STATE OF MAINE
DEPARTMENT OF TRANSPORTATION
16 STATE HOUSE STATION
AUGUSTA, MAINE
04333-0016

December 28, 2006
Subject: **Topsham**
Pin No. 14062.11
Amendment No. 2

Work under this contract is generally described as the construction of the MaineDOT TOPSHAM HIGHWAY MAINTENANCE GARAGE

DATE 05-19-06	SCALE AS SHOWN	JOB NO LP ENG 300-01-06	DRAWING NO V-1
BY L P Pelletier	CHKD

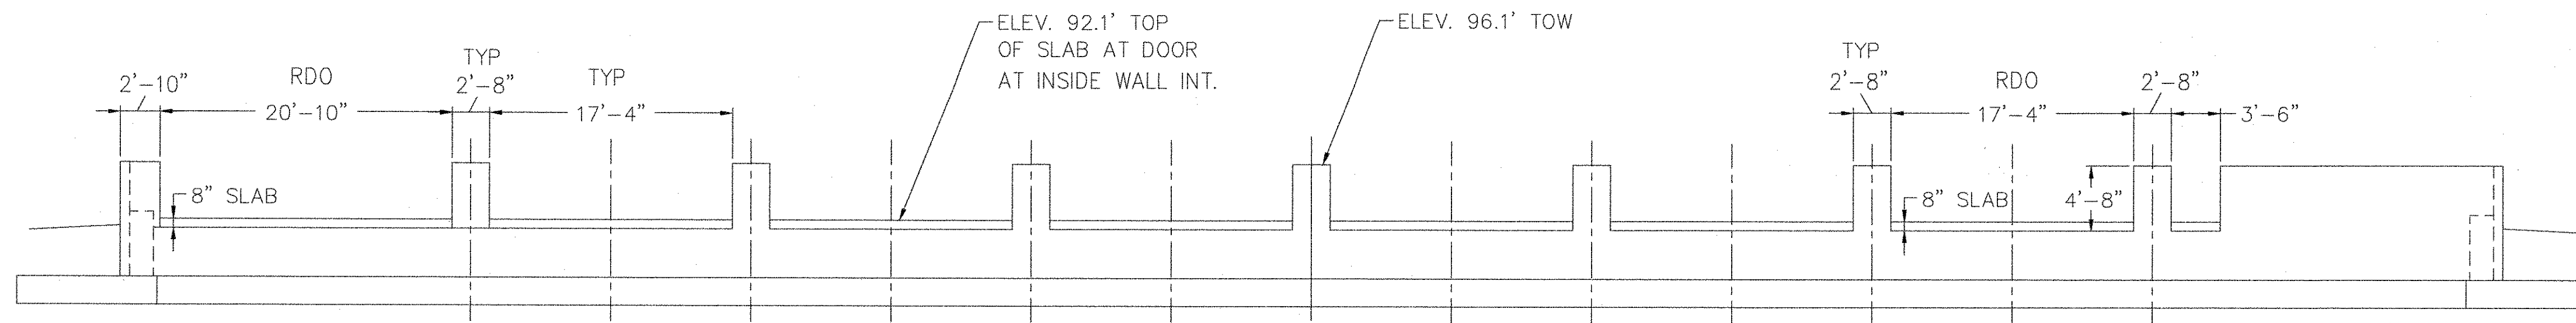
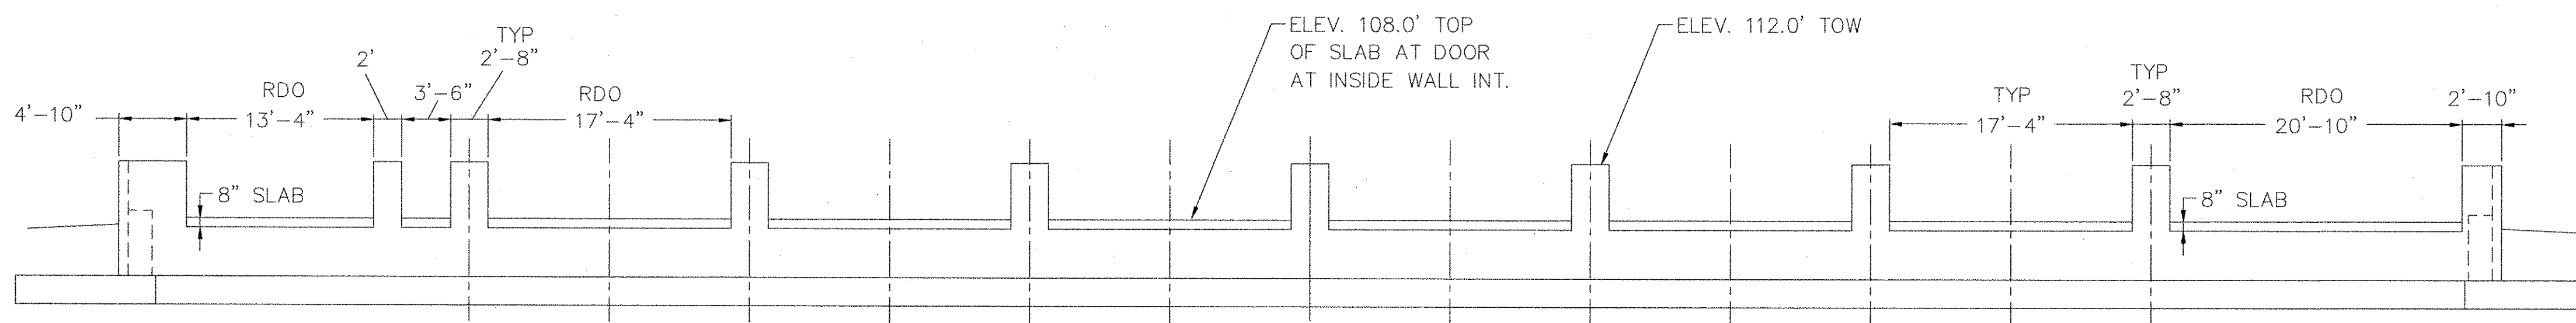
Question: Where are the dust collectors being located? There needs to be a CA run to them.

Question: The V-1 Equipment schedule appears to be (1) 5-Ton CU, (1) 5-Ton AHU and (2) 5-Ton DX Coils. Is this the intent?

Question: Where is the paint room noted to have an exhaust fan on V-1?

Response: There are no dust collectors on this project. The references to them have been removed in the attached updated Drawing V-1.

Response: The intent is to use one 5 ton unit and what is required for associated equipment.

Response: There is no paint room. The equipment specifications on Drawing V-1 have been revised on the attached updated Drawing V-1. It is now shown as a mechanical room.

DATE 05-19-06	SCALE AS SHOWN	JOB NO LP ENG 300-01-06	DRAWING NO S-2B
BY L P Pelletier	CHKD

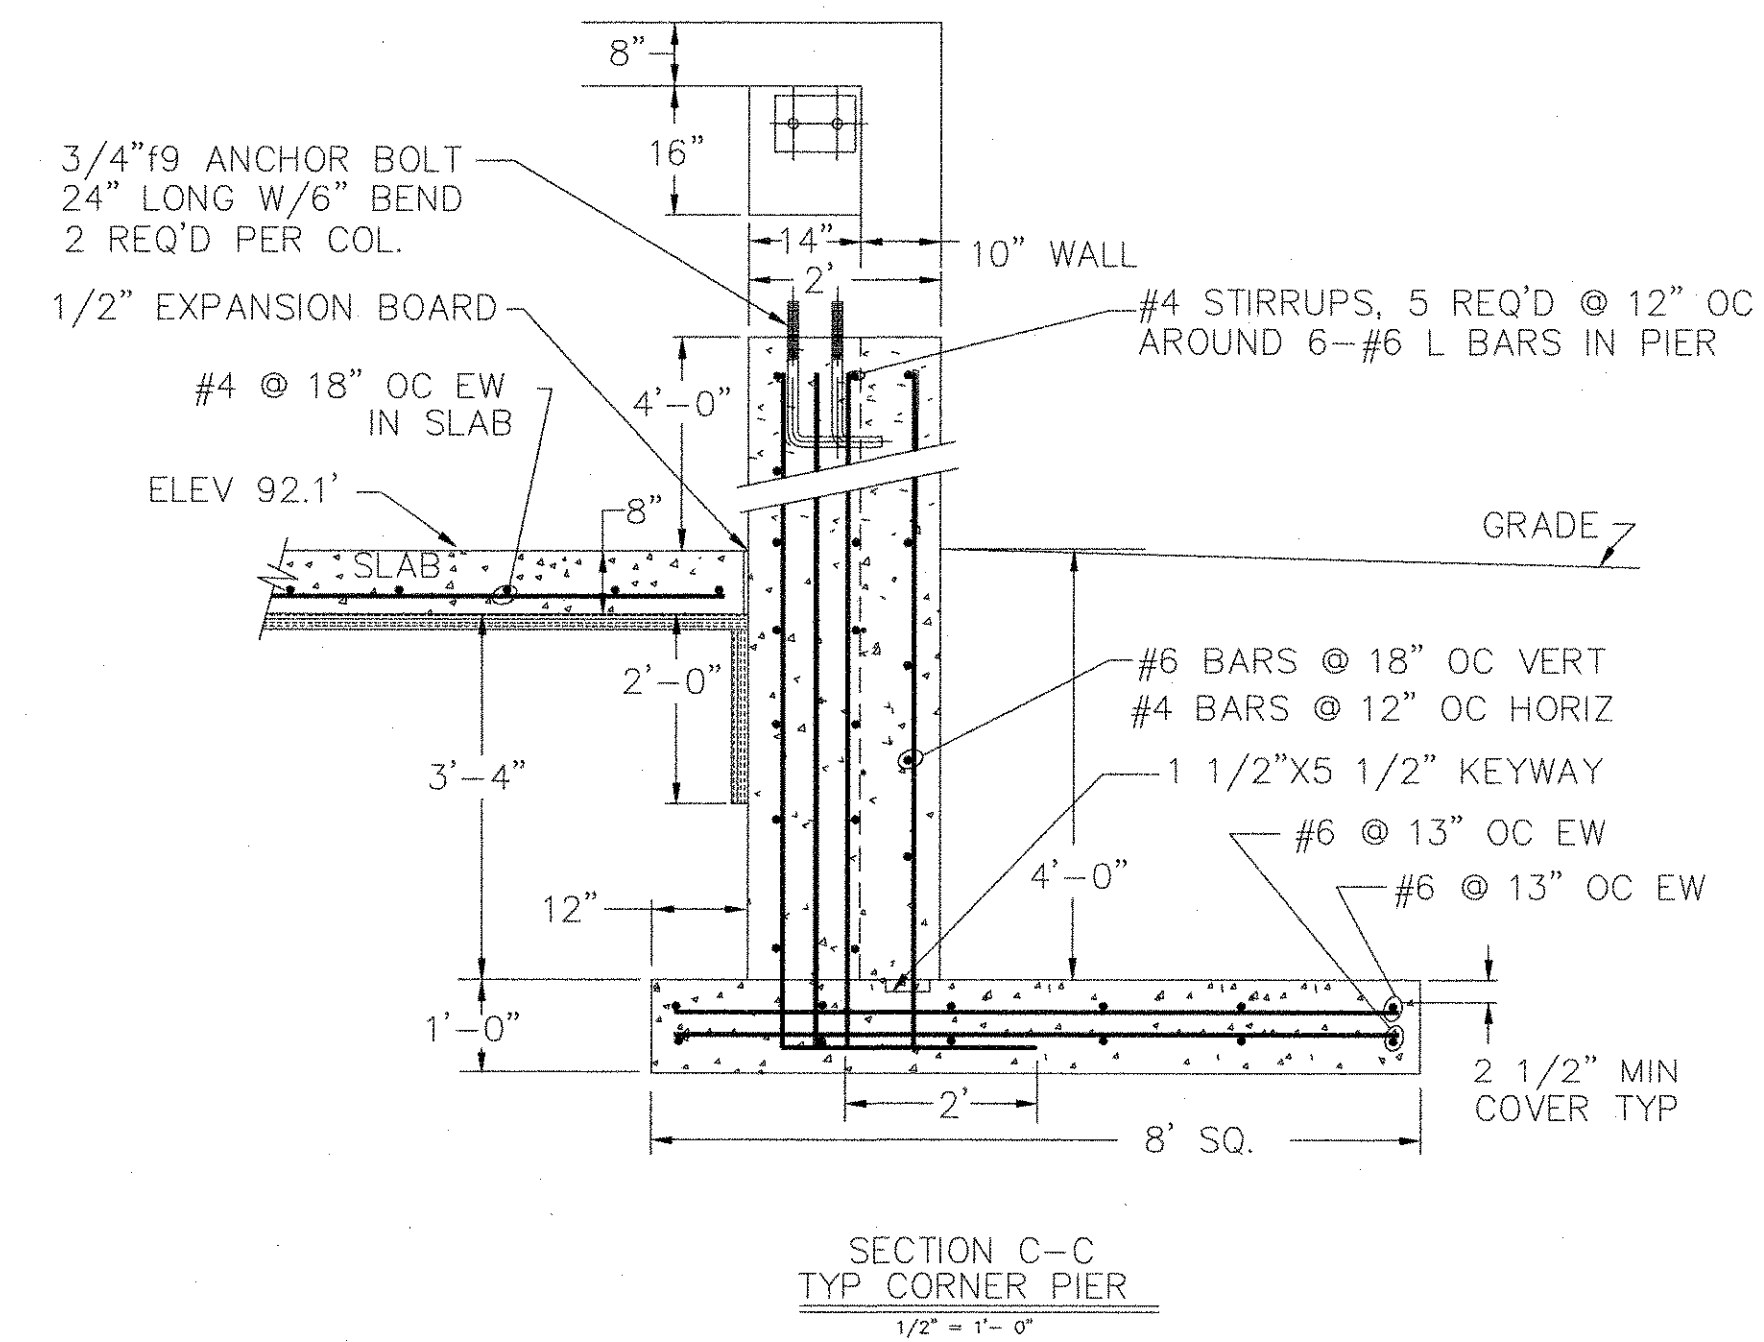
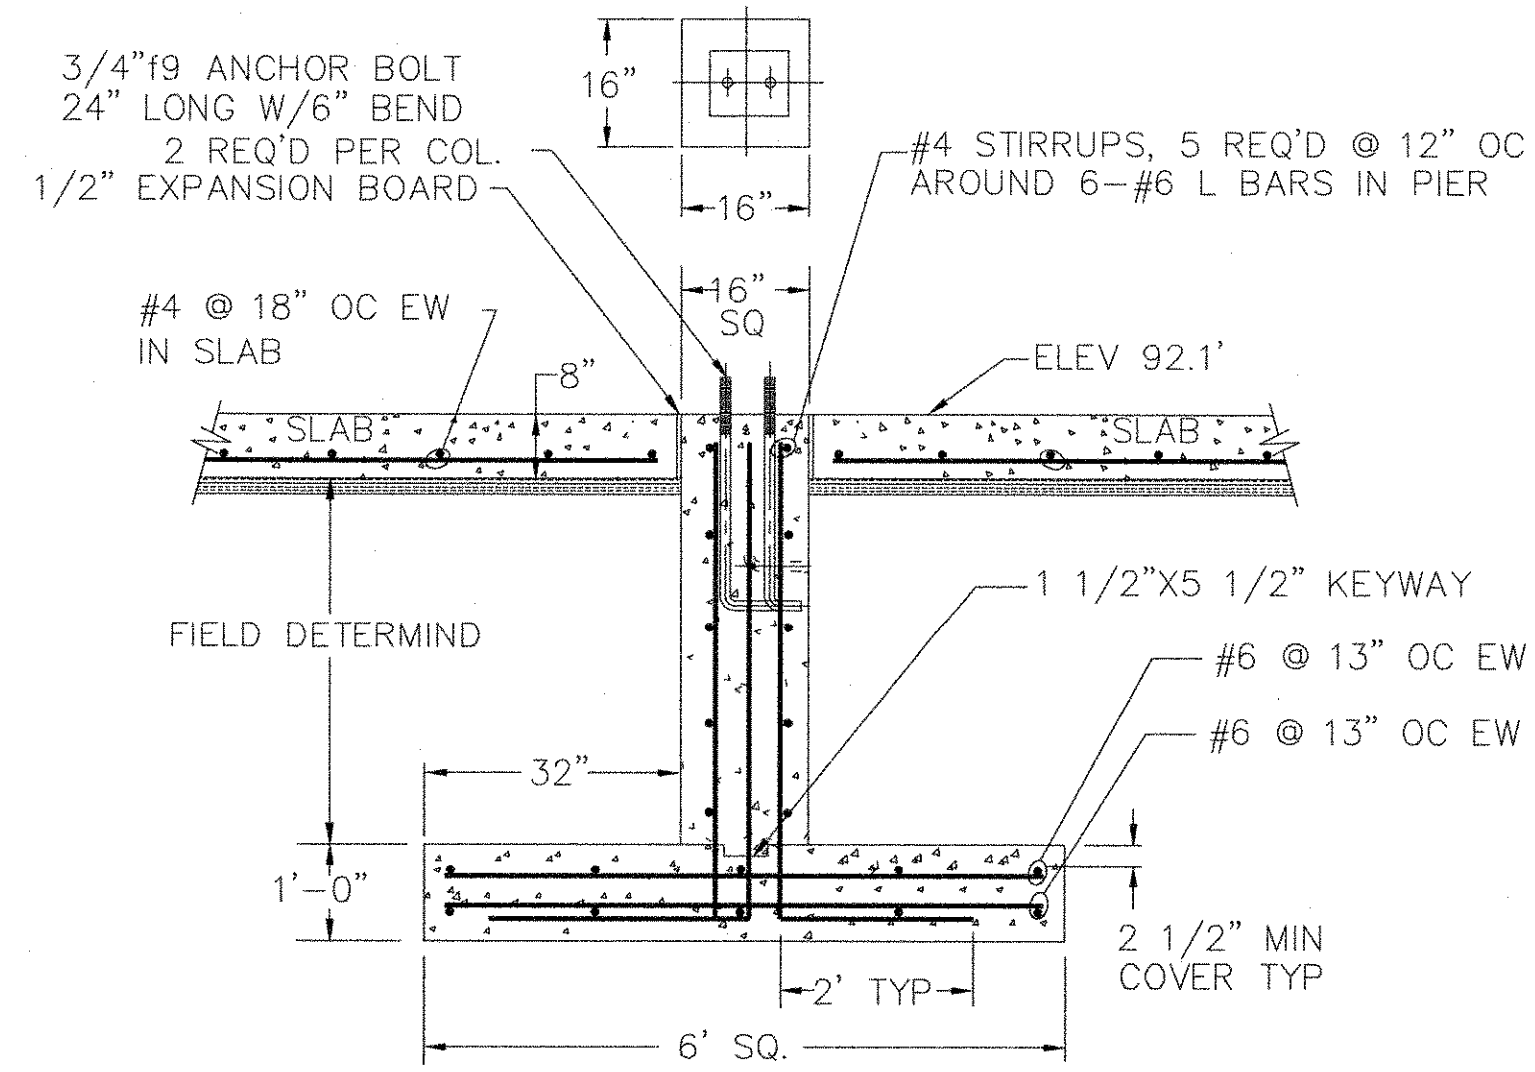
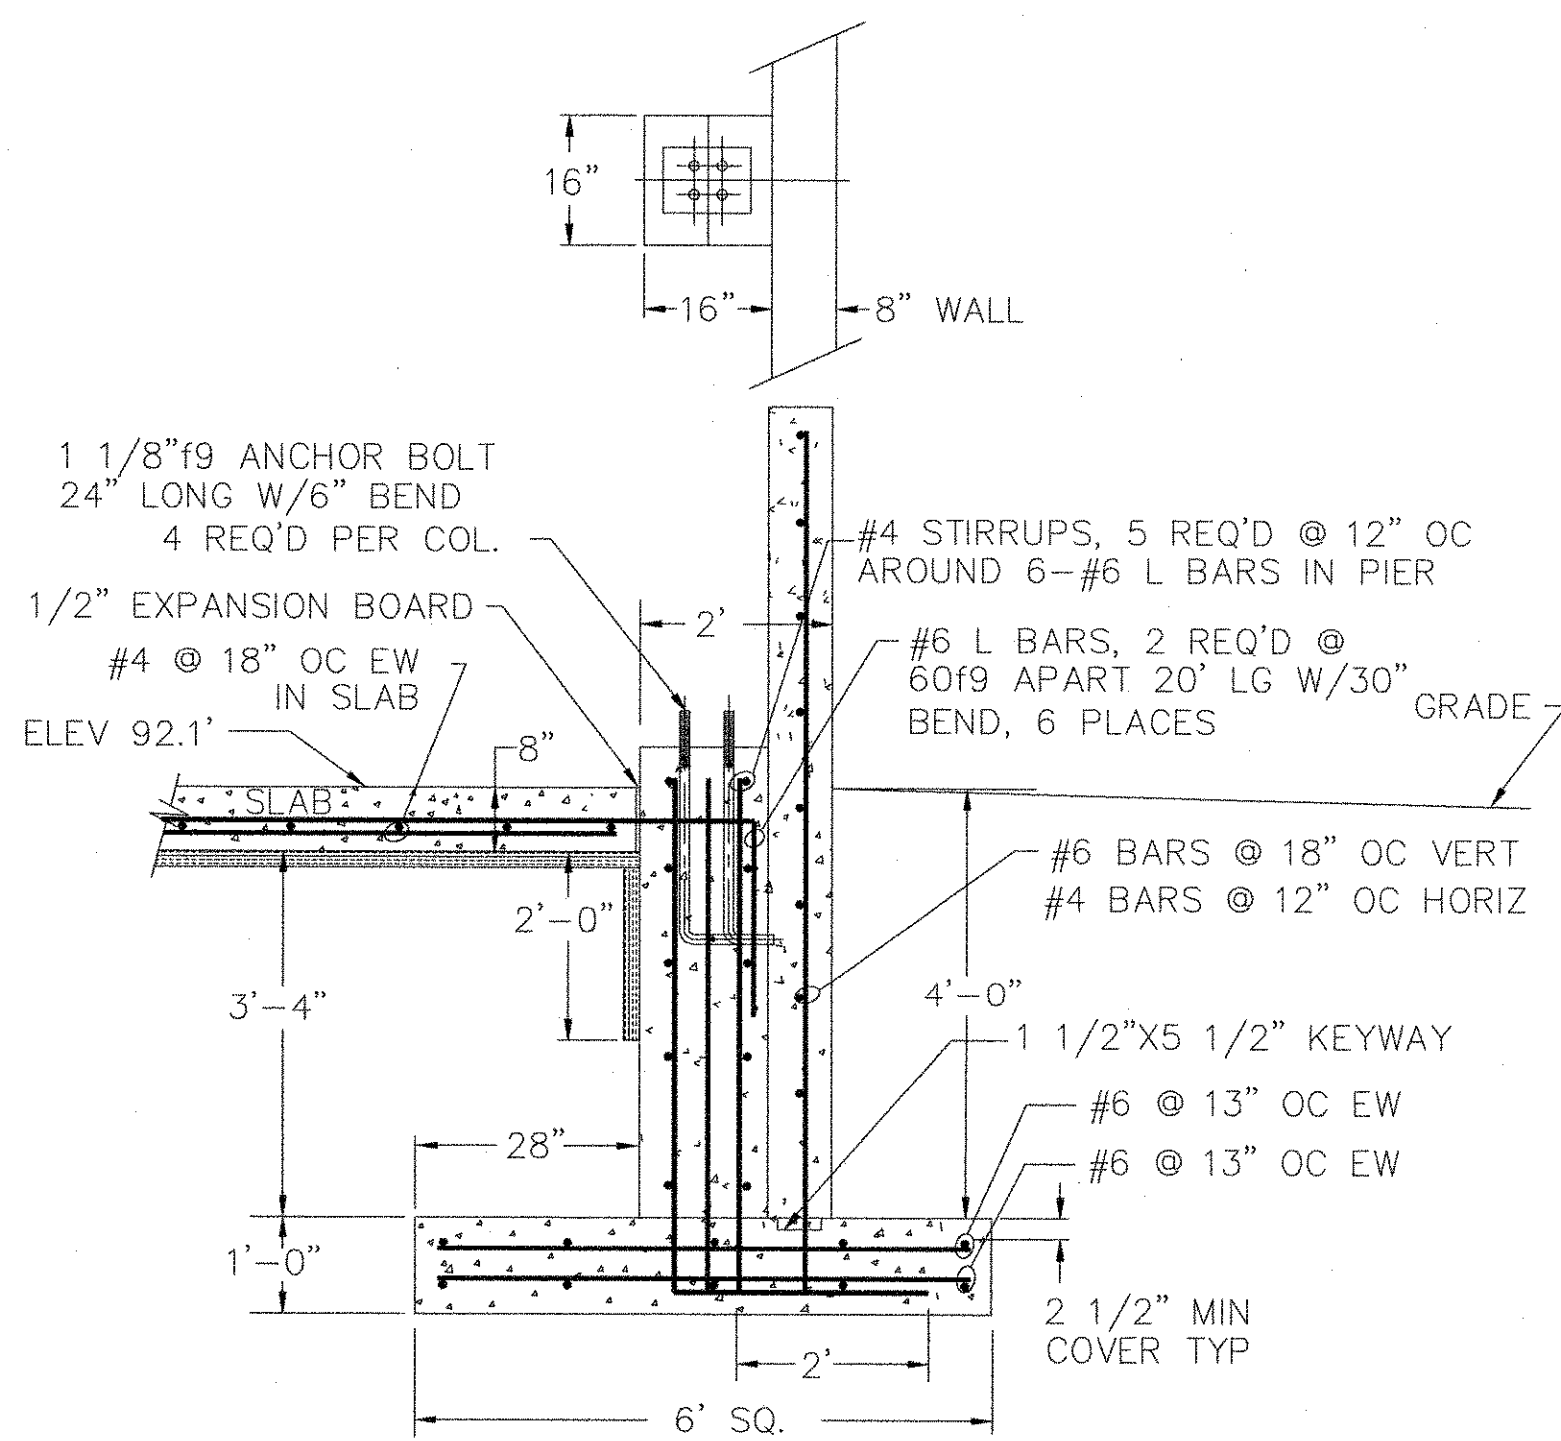
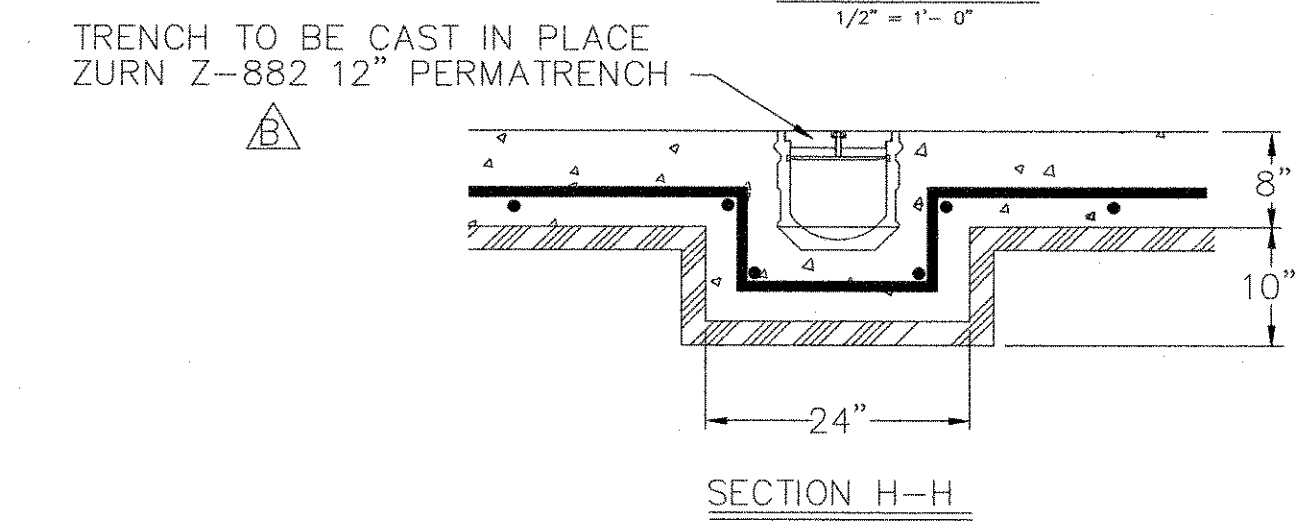
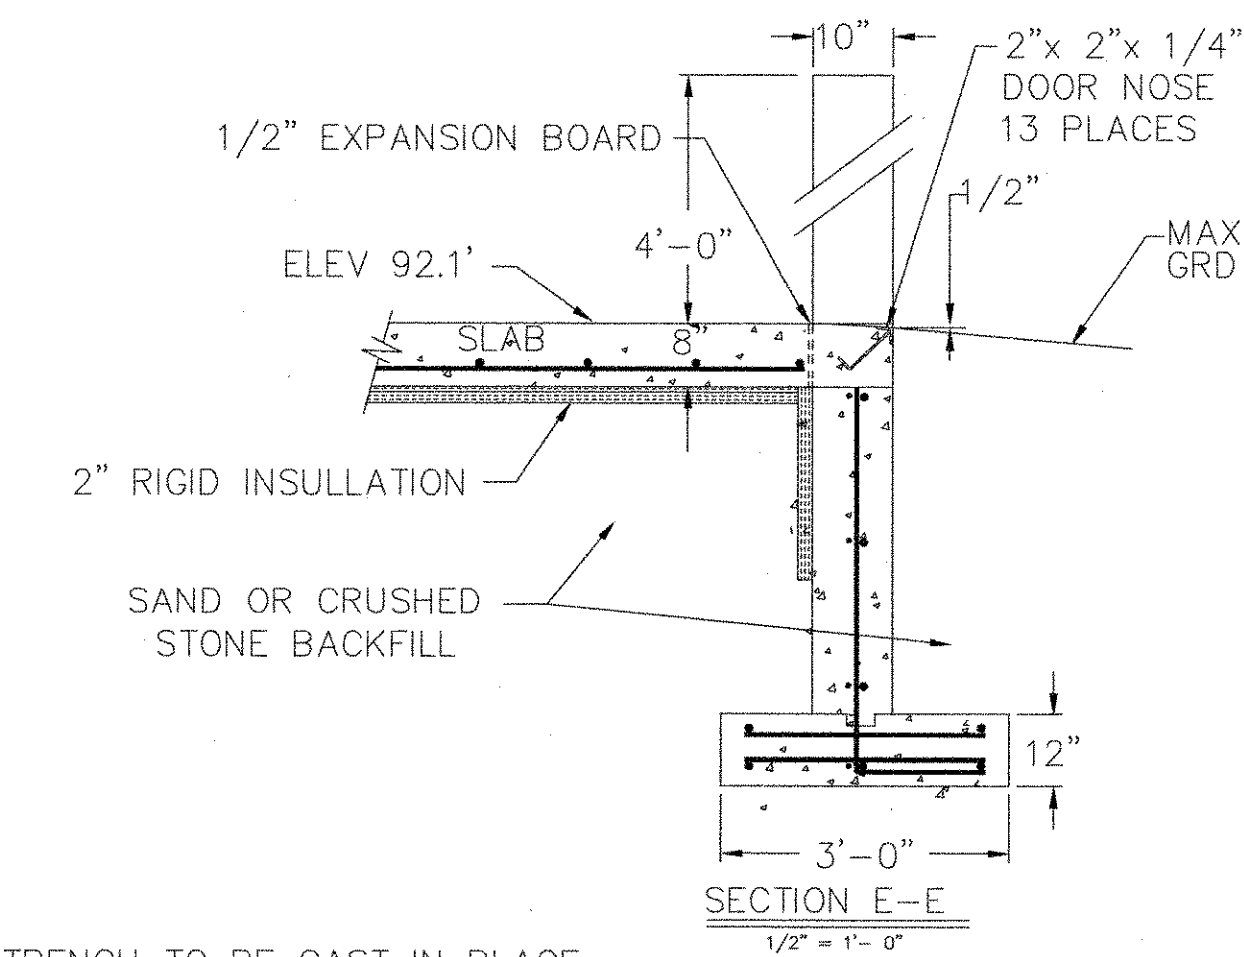
Question: Drawing S-2. Is the top of slab elevation 108.0 or 92.1?

Response: Drawing S-2 has been removed and replaced by the attached plansheet S-2A, the elevation is 92.1
